MIDLAND - UNDERGROUND PIPING

APPLICANT: Consumers Power Company
FACILITY: Midland Plant, Units 1 and 2
SUBJECT: SUMMARY OF OCTOBER 6-7, 1981 MEETING ON UNDERGROUND PIPING

Subject MIDLAND PROJECT -
UNDERGROUND PIPING MEETING WITH -
STAFF ON OCTOBER 6 AND 7, 1981 -
FILE 0485.16 SERIAL 14704

LEAKAGE TEST ACCEPTANCE CRITERIA

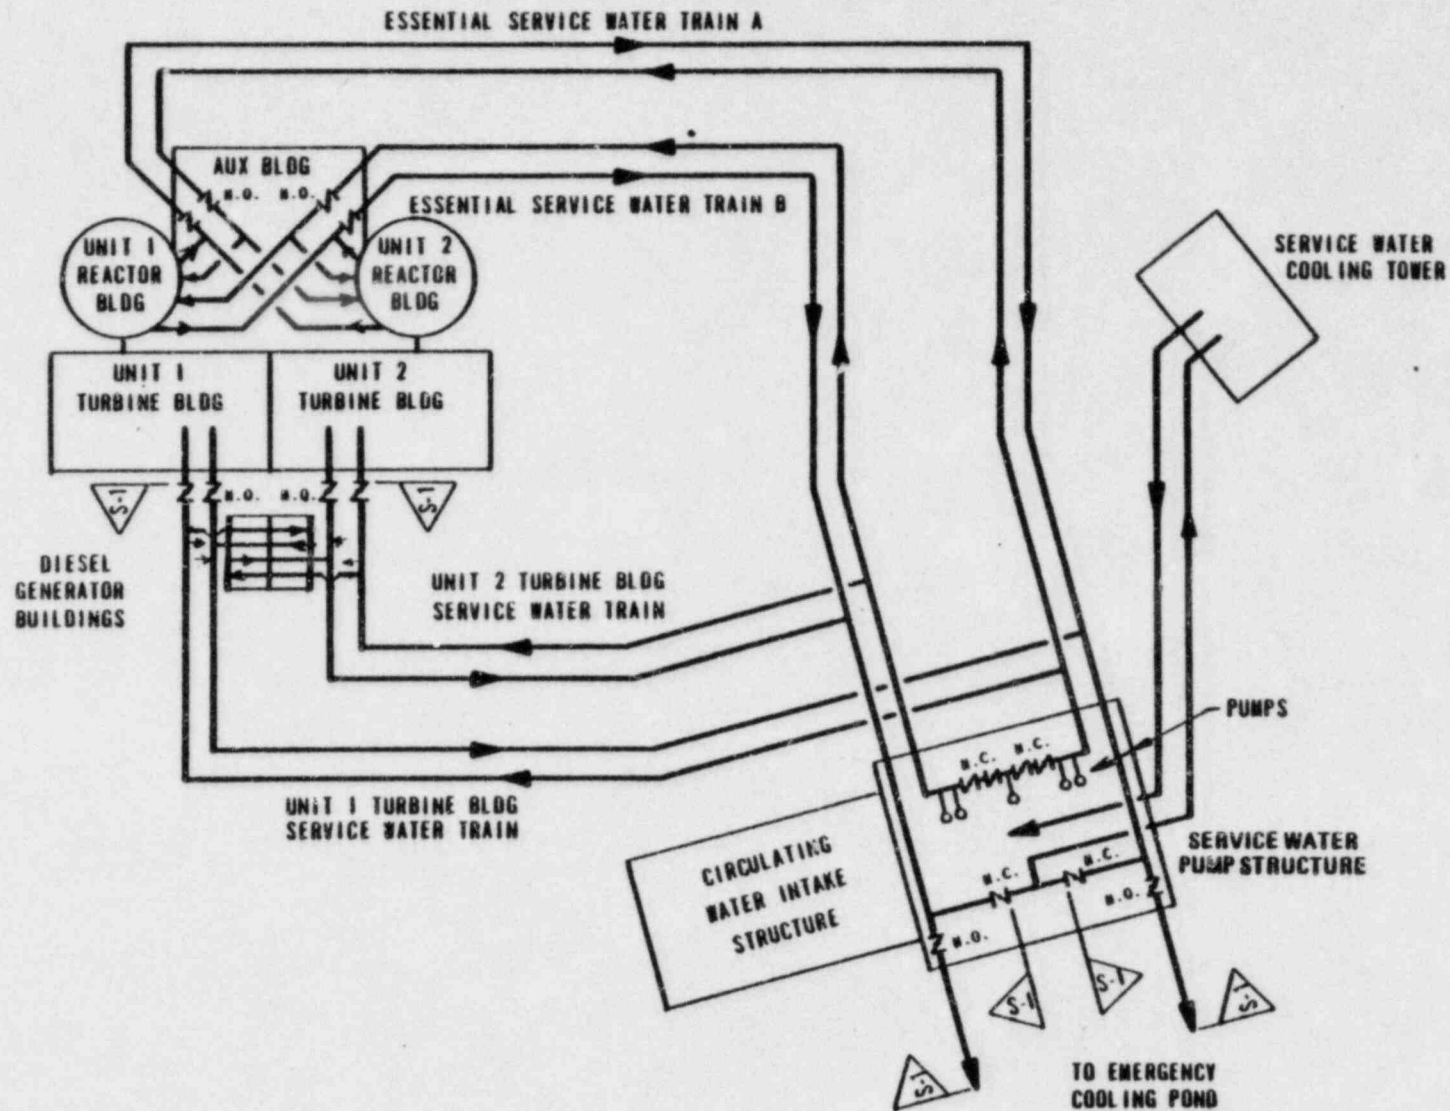
(A correction to the slide on acceptance criteria was noted; the entry reading 0.5 gpm should read 0-5 gpm.)

- SMALL ENOUGH TO DETECT PRESSURE BOUNDARY FAILURE
- LARGE ENOUGH TO ACCOMMODATE ANTICIPATED BOUNDARY VALVE LEAKAGE
- ⁰⁻⁵~~0.5~~ GPM
- RESULTS IN INSIGNIFICANT FLOW LOSS
- TO BE REVIEWED FOLLOWING PRESERVICE TESTS

LINEAR ELASTIC ANALYSIS RESULTS FOR UPPER BOUND SOIL PROPERTIES

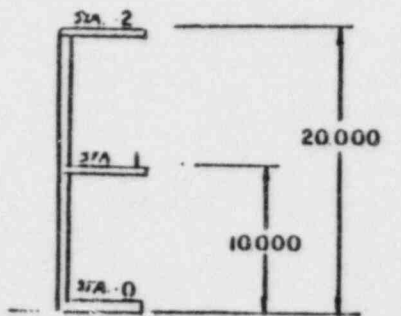
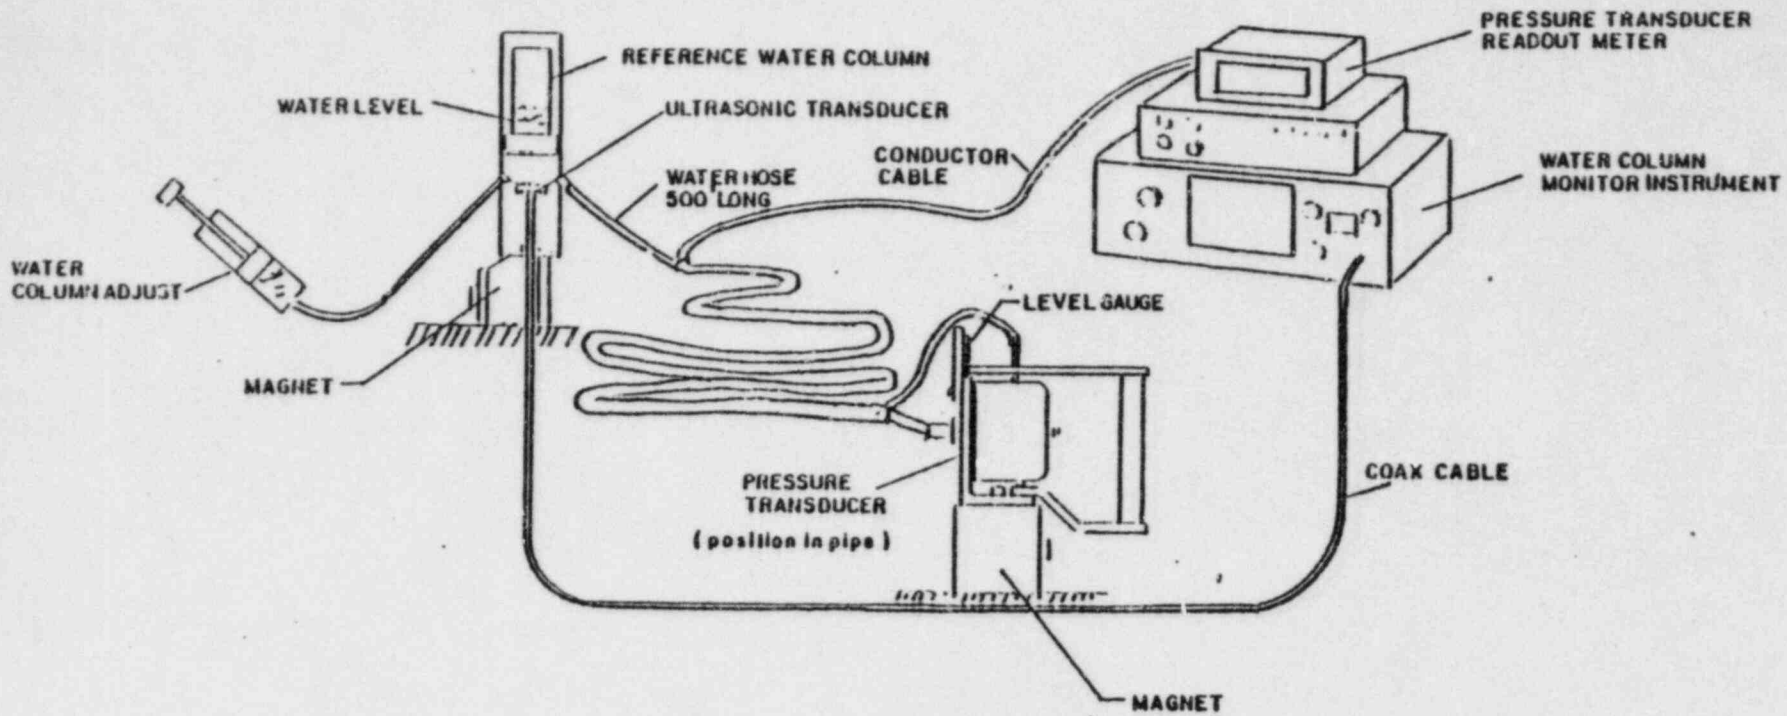
SMA has performed calculations (results on attached slide) to determine the soil loading which would have been required to cause the observed deformations if settlement were the only deformation mechanism. This study showed soil loadings necessary to be as much as three times the conservative estimate of the soil capacity. The limited information available about presettlement, as-built conditions thus is shown to provide an unrealistic calculational solution. H Singh (COE) questioned the assumptions used in this analysis; specifically that of a uniform soil spring constant. It was explained that the analysis showed that in order to force the pipe into its present condition the soils could not apply enough force to do this.
